# STEENSEN VARMING

This letter is in regard to the design change in selection of heat rejection systems serving the Sydney Modern development cooling systems and a subsequent letter to a previous response issued 'Ref.No.14702.PL.M.02 dated May 3<sup>rd</sup>, 2019'.

The previous letter of response provided basic rationale and technical benefits to the change of heat rejection. This letter will cover the further clarifications requested by the 'City of Sydney' (CoS) in letter Ref 'R/2014/13/D'.

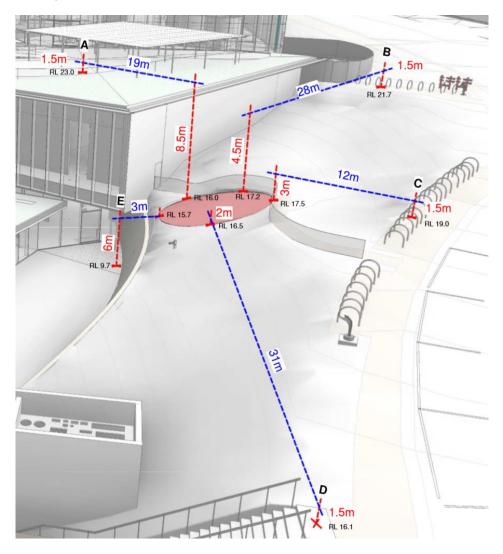
When investigating possible locations for siting the cooling towers the perceived discharge and air movement around the grille was carefully considered. The grille is located far enough from any point of busy thoroughfare and place of congregation to ensure that the exhaust is not a health or nuisance to the public or users of the building. The below image has been produced by Architectus to show the proximity of the grille to places of public and Gallery use.

Points A through to D are all sufficiently far enough away in the horizontal plane to ensure there will be no perceived sensation from the cooling tower discharge. Point E is only 3m in the horizontal plane but sufficiently far below in elevation to ensure the discharge will not be physically perceived as the warmer air will be rising.

It should be noted that there is a fire escape door leading to a pathway which passes adjacent to the grille. This will only be used in emergencies and will act only as a pathway and not a place for congregation. If someone is evacuating the building
